**RE: McMahon Commons
Conceptual Grading & Drainage Plan
Engineer's Stamp Date: No Date
Hydrology File: A10D002G**

Based upon the information provided in your submittal received 08/06/2024, the Conceptual Grading & Drainage Plan **is not** approved for action by the Development Hearing Officer (DHO) on Preliminary Plat. The following comments need to be addressed for approval of the above referenced project:

PRELIMINARY DRAINAGE PLAN

McMAHON COMMONS

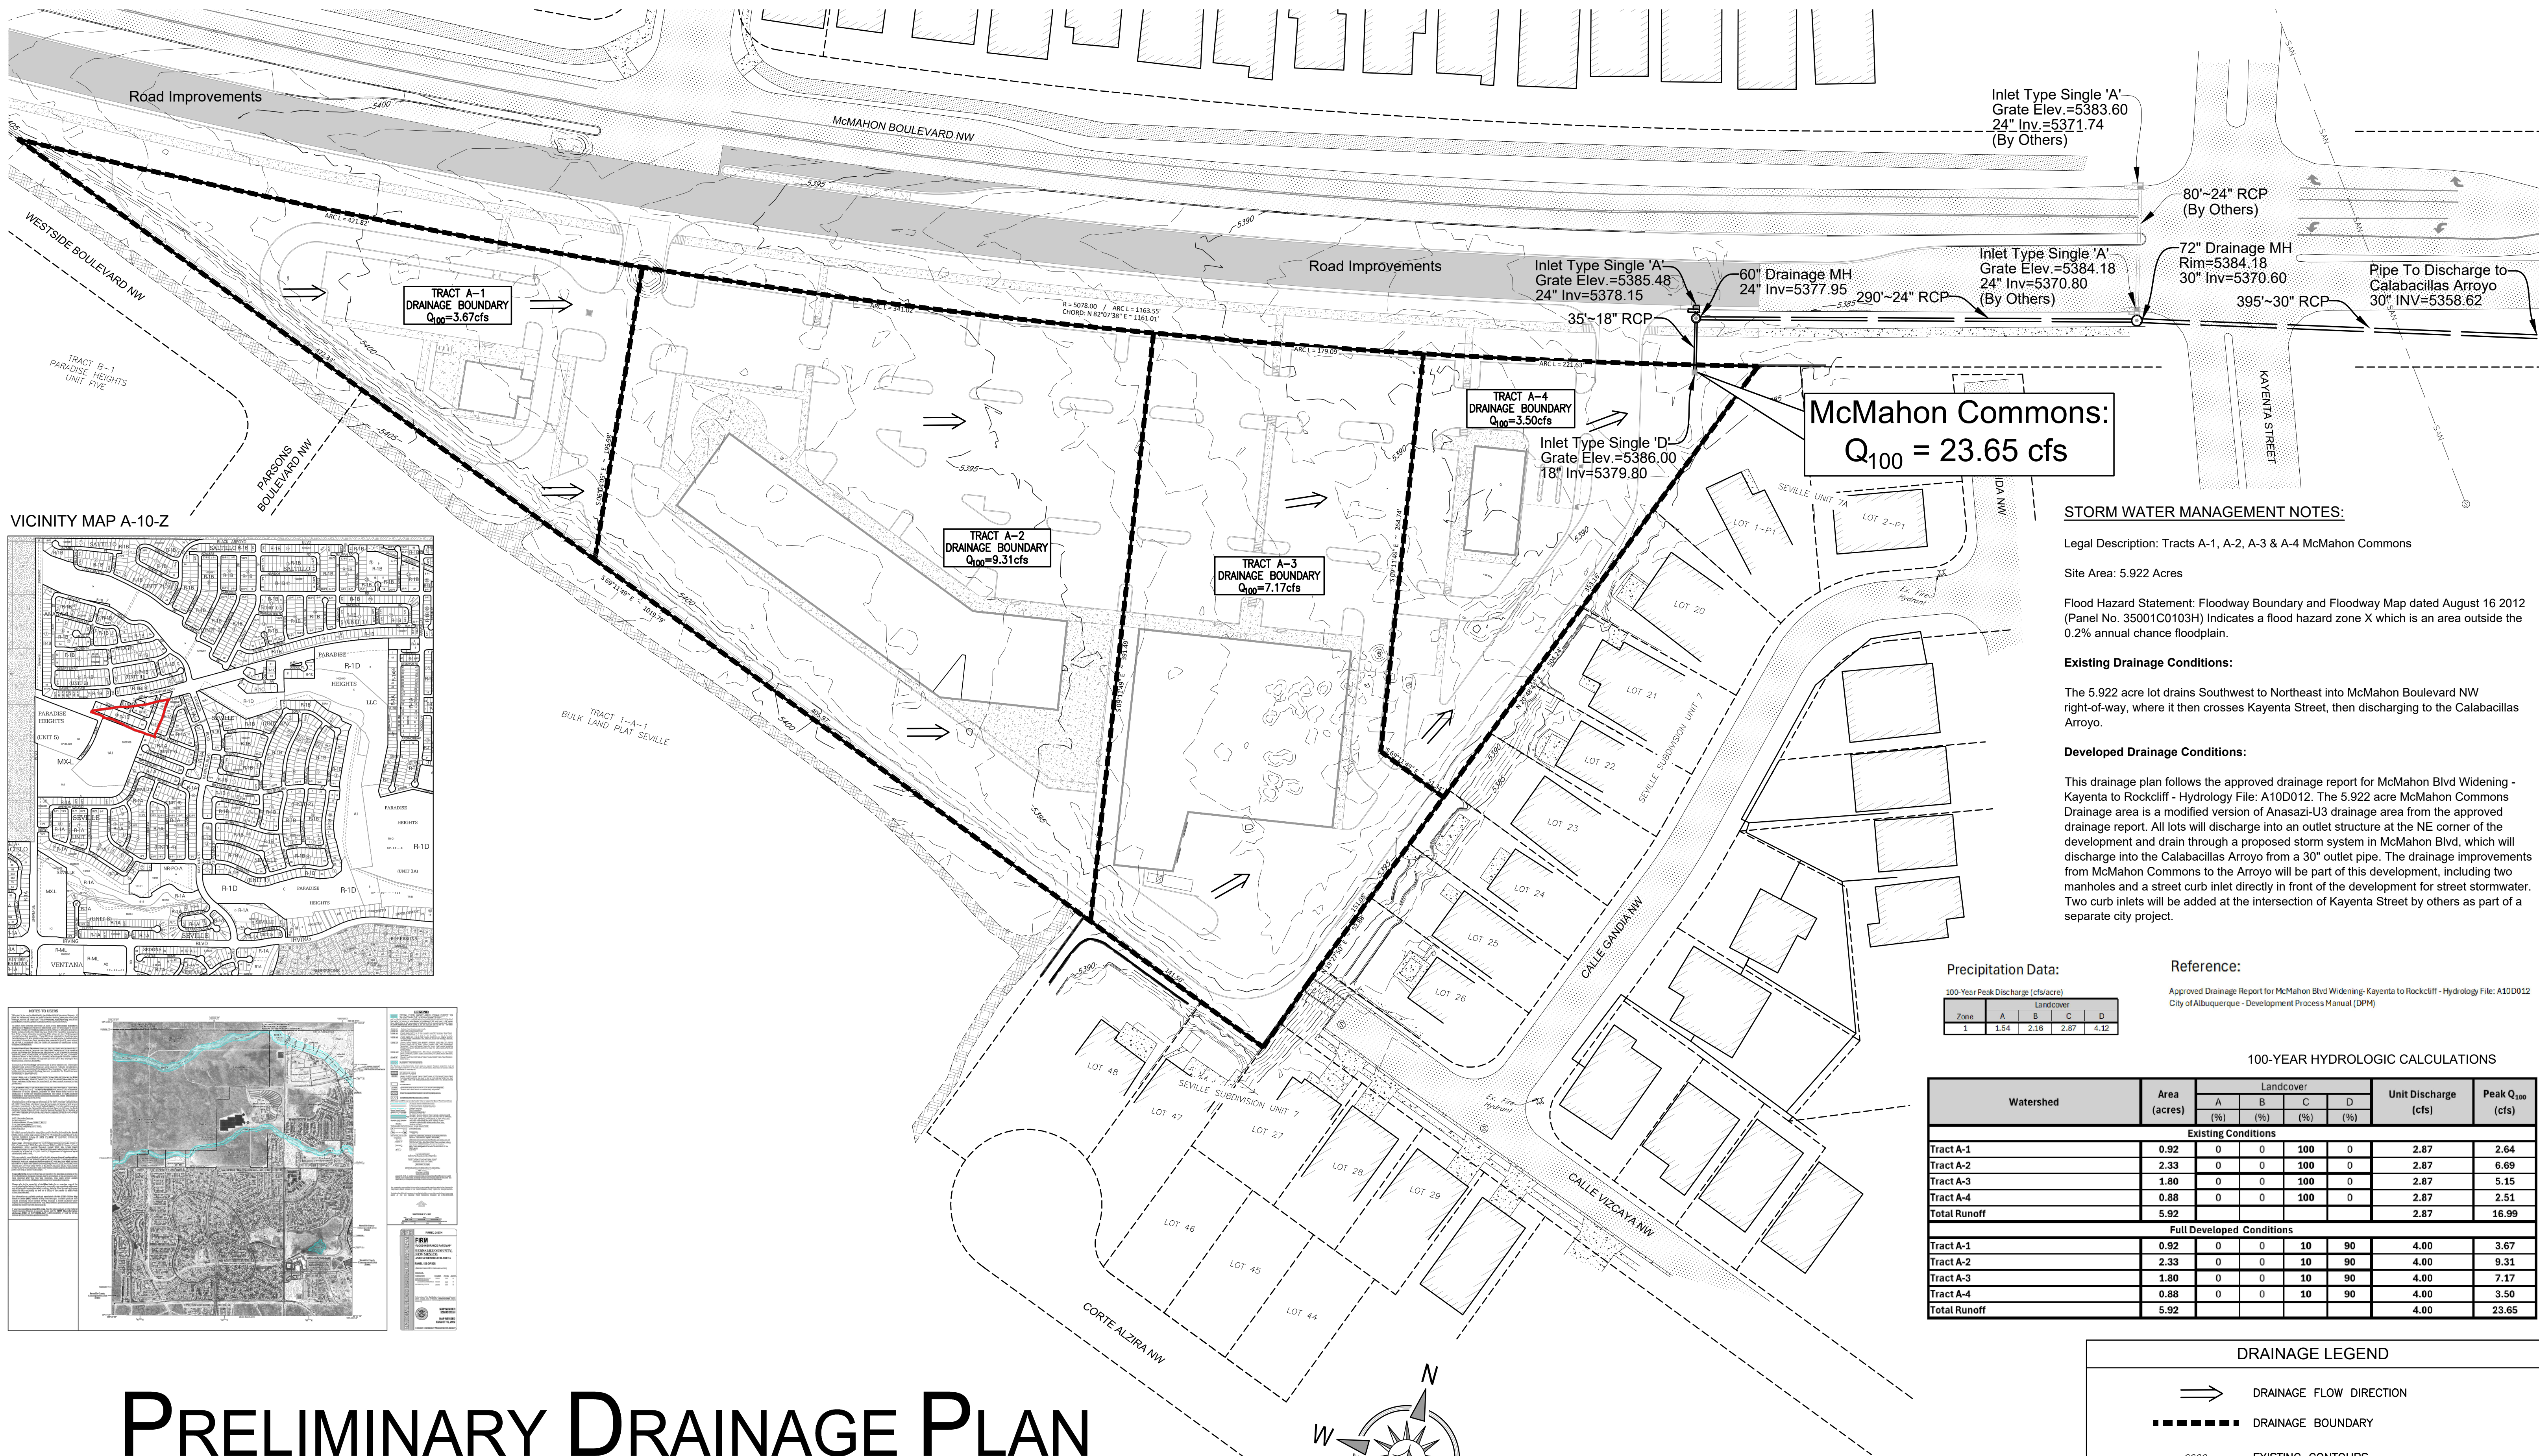
1. Please show the Stormwater Quality Pond for the entire commercial development.

2. The proposed inlets, proposed storm pipes, and proposed manholes within McMahon R.O.W. along with the outfall into the Calabacillas Arroyo cannot be labeled as “By Others”. All of this system is needed for this development and needs to be included in the Infrastructure List during the Preliminary Plat approval.
